Plan Commission

SUBJECT: Review the Site Plan application for an 8,174 sq ft addition to 1001 Main Ave, parcel WD-D0200-2 (Festival Foods). Applicant: Bayland Buildings.

- Item 3:** Review the Site Plan application for an 8,174 sq ft addition to 1001 Main Ave, parcel WD-D0200-2 (Festival Foods). Applicant: Bayland Buildings.

FESTIVAL FOOD DEPERE

1 EXISTING SITE PLAN
C1.0 1" = 40'-0"

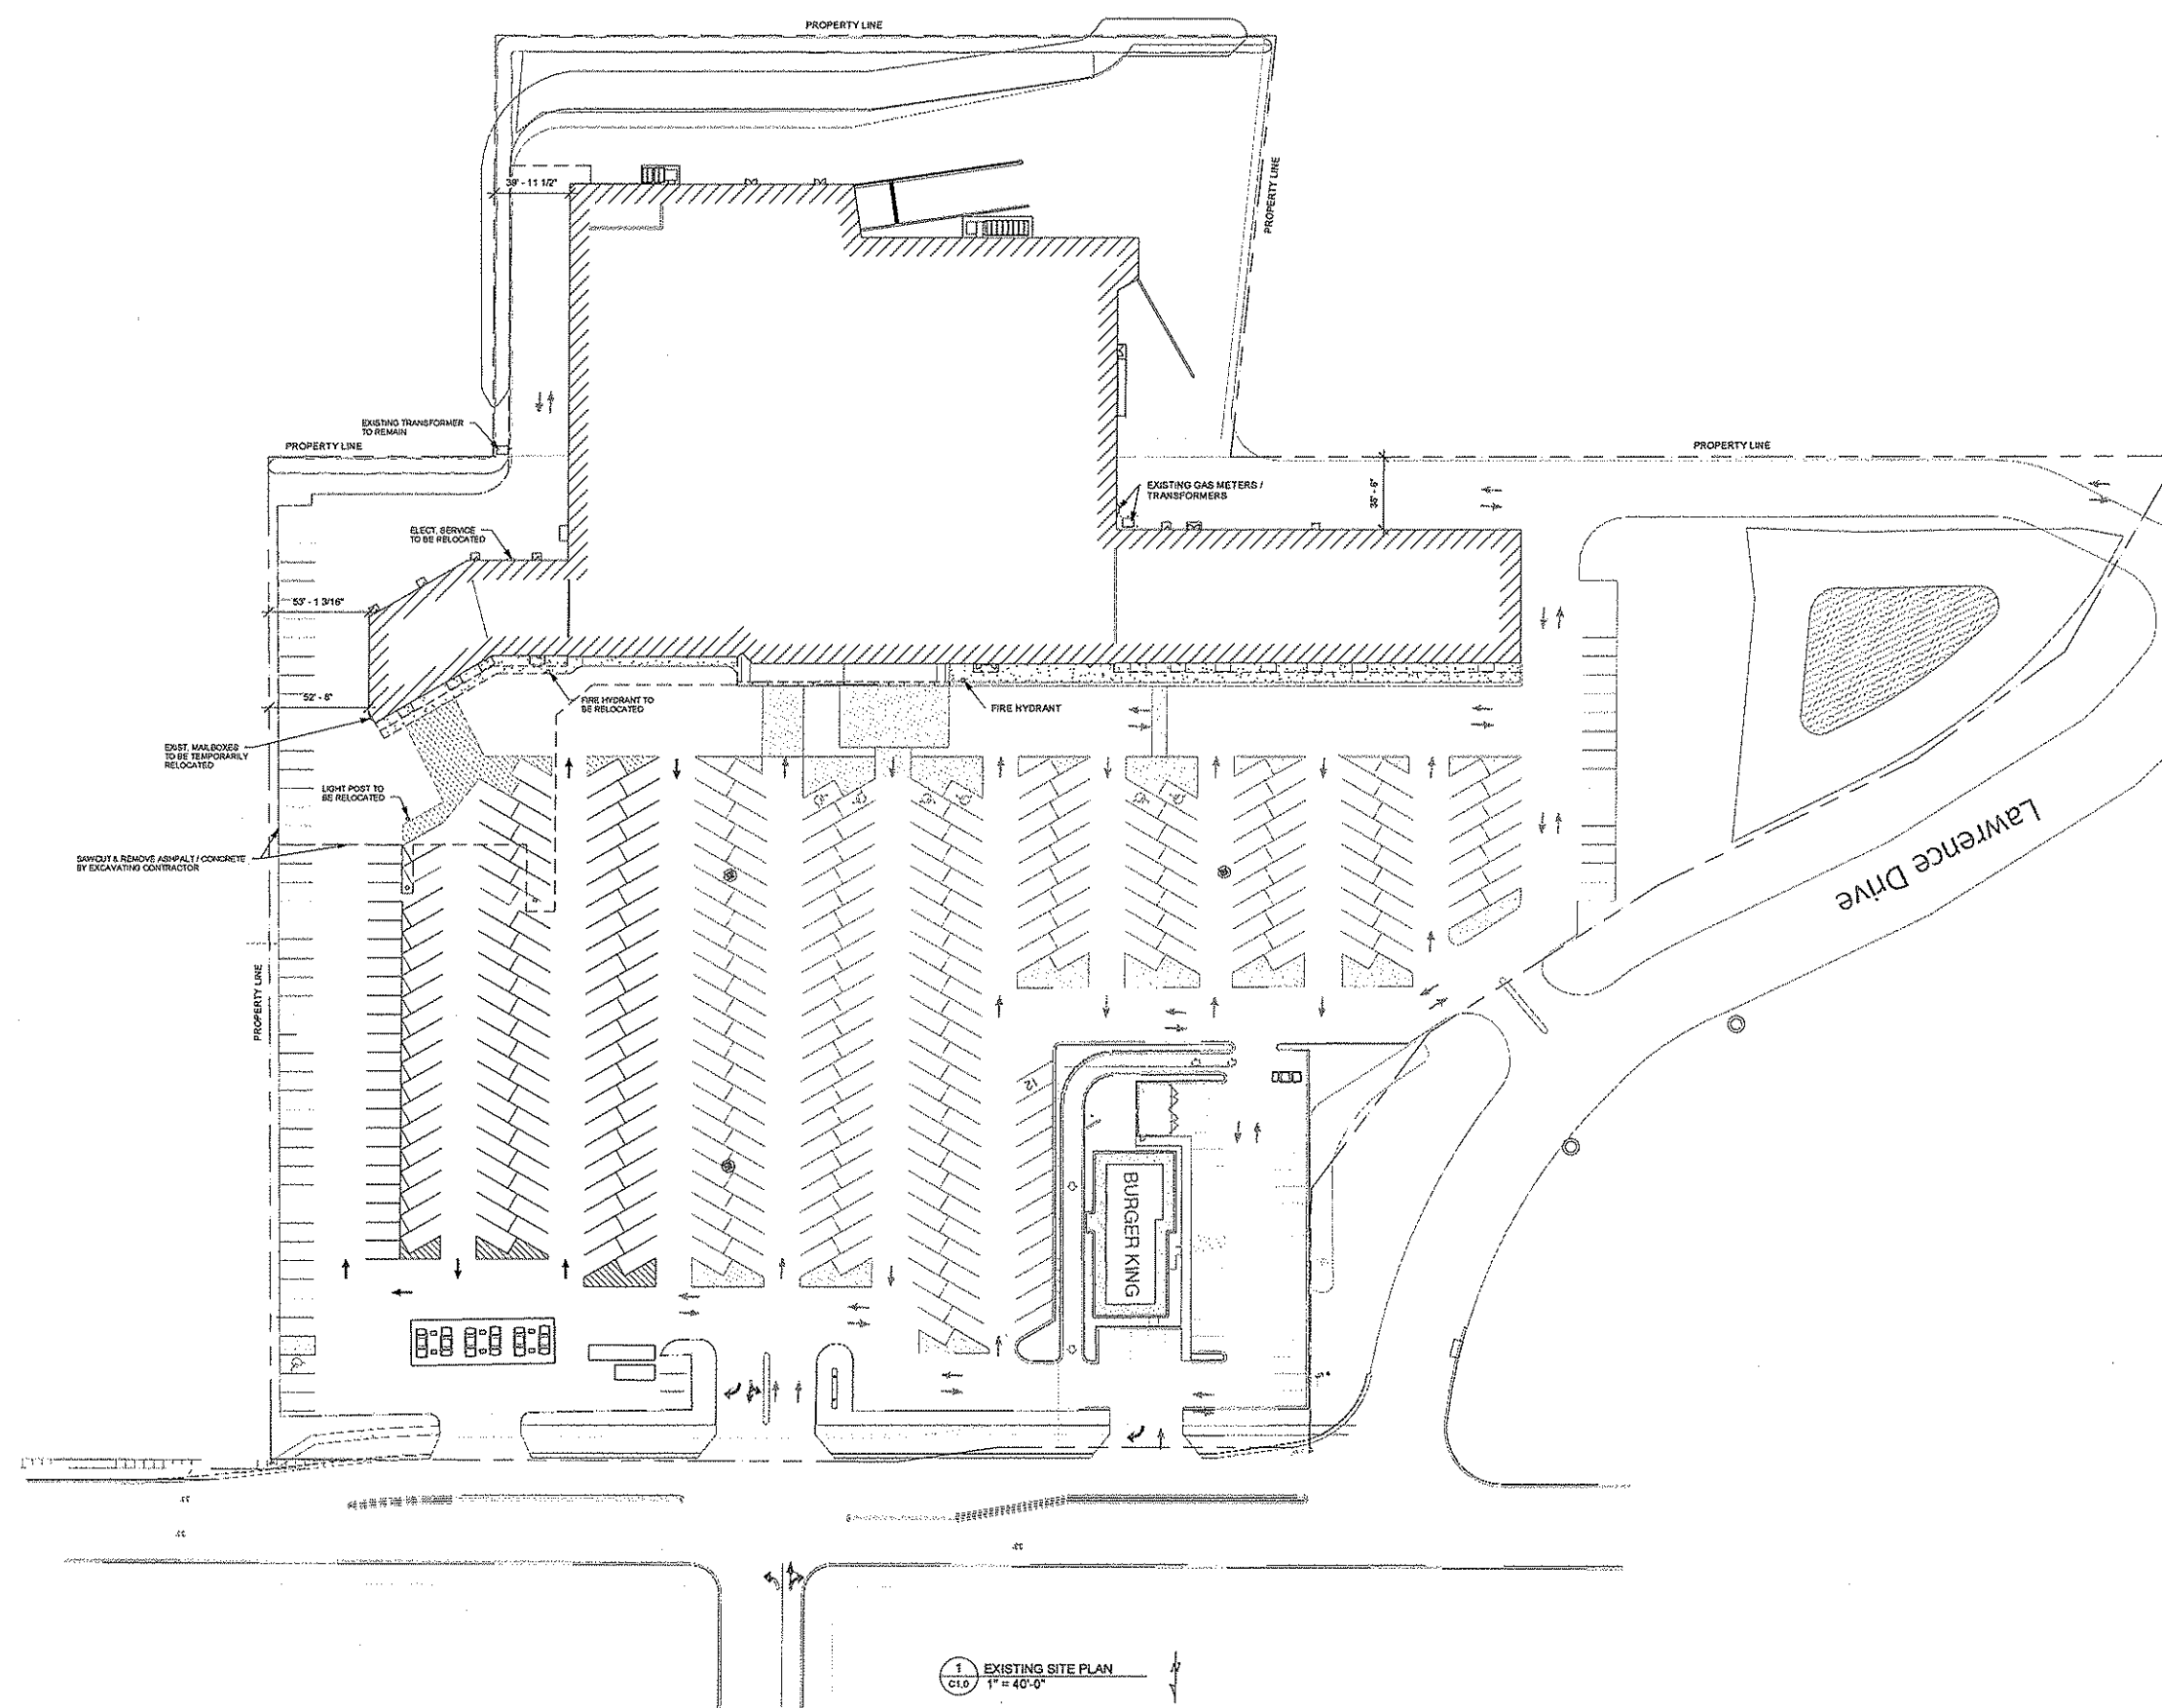
1. Show property address on the plan and list name and address of owner on the plan.
2. Label "Main Avenue" on the plan.
3. Provide erosion control plan for the site.
4. Show the existing water and sewer laterals to the building. Show water line and label as "private".
5. No underground utilities are shown. Provide a plan with existing utilities so it can be reviewed.
6. Show the location of any new water and sewer service connections on the plan.
7. Provide a safe water sample for the extended water main to the City of De Pere Water Department before connections are made to the pipe. Request new meters at least 5 business days in advance of needing them installed. Water meters larger than 1" will require one month advance notice.

Staff would recommend approval of the site plan with the following items identified above being addressed.

1 PROPOSED NORTH ELEVATION
A2.1 3/64" = 1'-0"

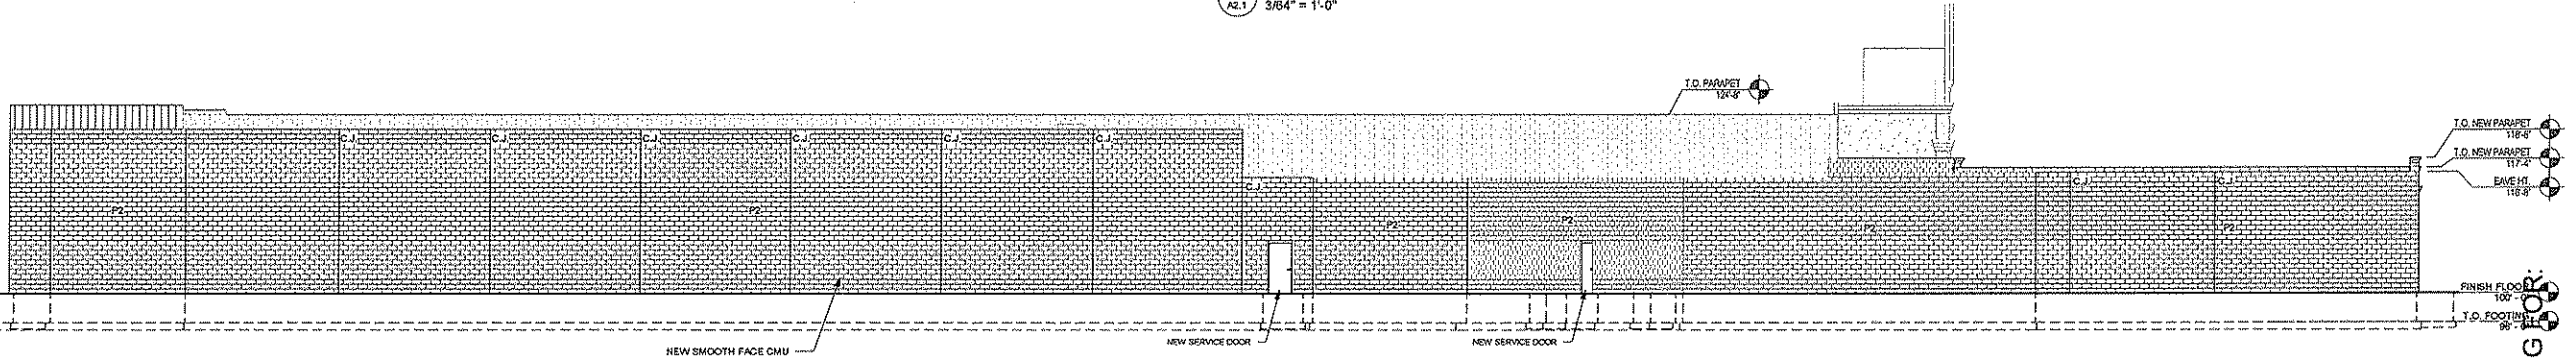
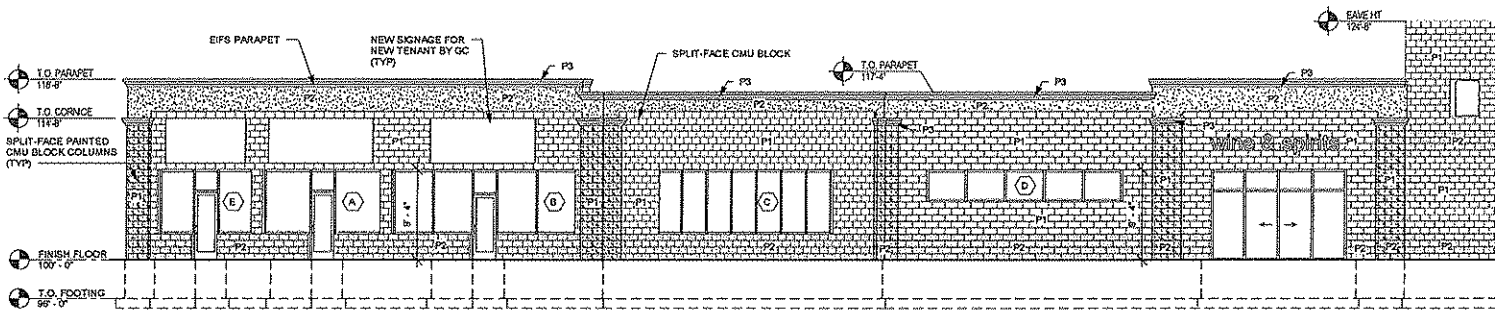
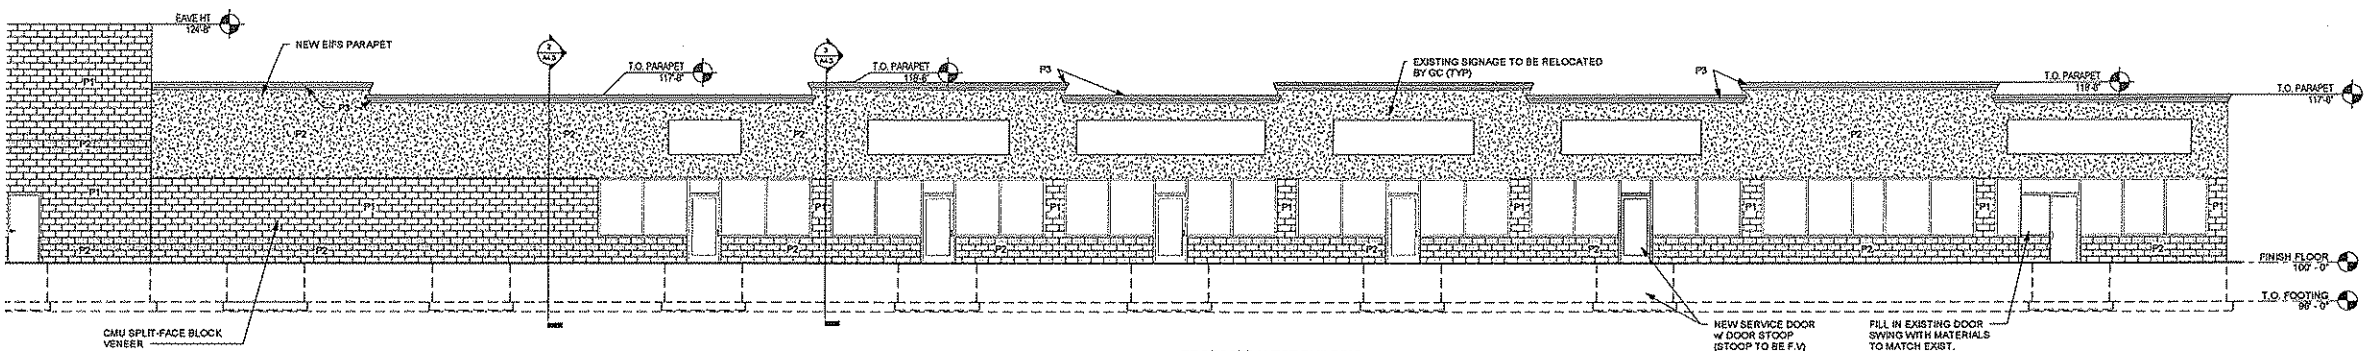
1. The elevations and material used will match the existing building in order to meet the code requirements.
2. Signage for tenant locations will need a sign permit.
3. The plans need to be approved by the State before permits can be issued.
